TOWN OF MORRISTOWN DEVELOPMENT REVIEW BOARD
WARNED PUBLIC HEARING
COMMUNITY MEETING ROOM OF THE OLD TEGU THEATER
43 Portland Street in Morrisville, VT 05661
6:00 PM Wednesday, August 12, 2026

TO: Morrisville DRB
FROM: Holden S. Thompson, EI, B. Dexter Lefavour, PE
SUBJECT: **N.A. Manosh 5 Mountain Minerals Application #2026-59 Response**
DATE: August 7, 2026
CC: Nick Manosh

PROJECT DESCRIPTION: 2026 -59- Major Subdivision, and Conditional Use Review application submitted by Nick Manosh for a property located at 400 Ferland Pit Road. The Applicant is seeking Major Subdivision Review for a proposed 4-lot subdivision. The lots are as follows: Lot 1. 28.5 acres, Lot 2. 19.4 acres, Lot 3. 10.9 acres, Lot 4. 43.5 acres. The Applicant is also seeking conditional use approval for new gravel pits located on proposed Lots 1. & 2. The Applicant plans to phase the gravel pits in two phases. In addition, the Applicant is seeking to establish a water bottling plant on proposed Lot 3. This project will be reviewed under the 2023 Zoning Bylaws with emphasis on the following Sections: Section 204.5a-b, 485, Article V., 630, 660, 750, 760, 770, and Article VIII.

TO: Morrisville DRB
FROM: Holden T

C-6

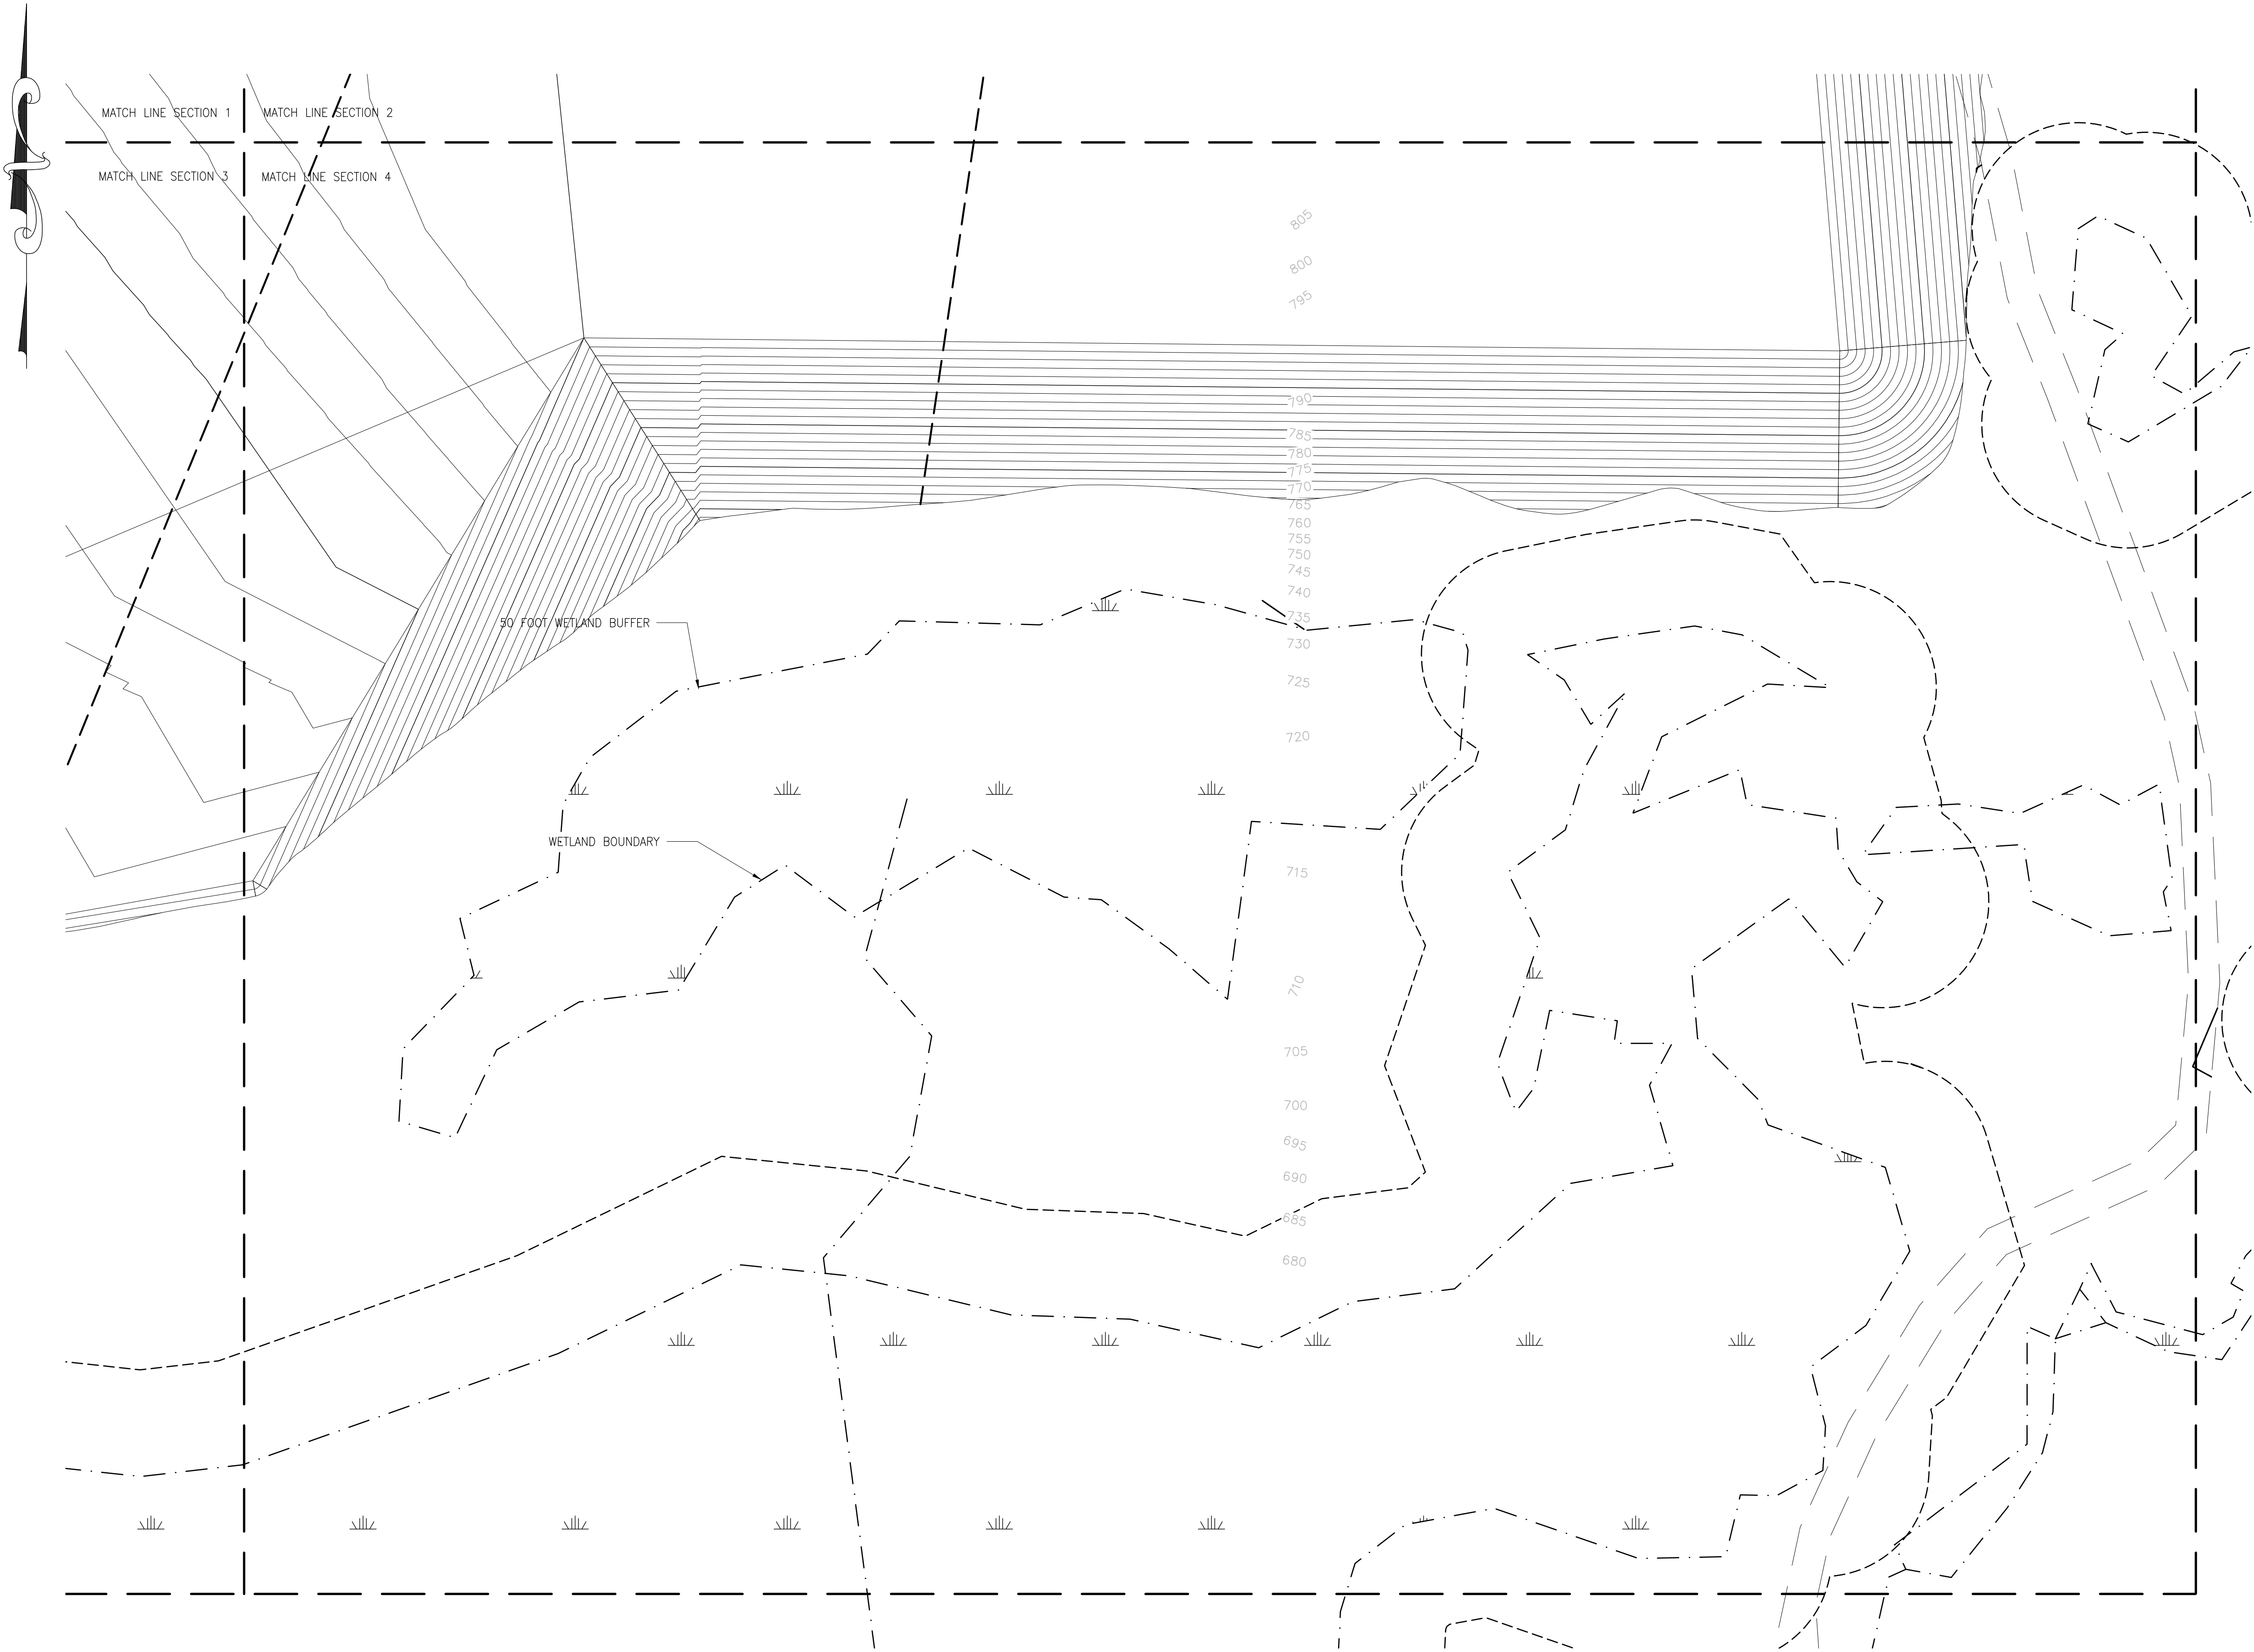
The staff notes indicate a concern for setbacks to roads and property lines in the NW corner of the site. It is assumed that this comment is intended to refer to the setback to Garfield Road. The soil extraction pit limits have been adjusted to be at least 200' from the property line along Garfield Road, as defined by Section 485.5. These changes are reflected on Sheets C-1, C-4 and C-6 of the plan.
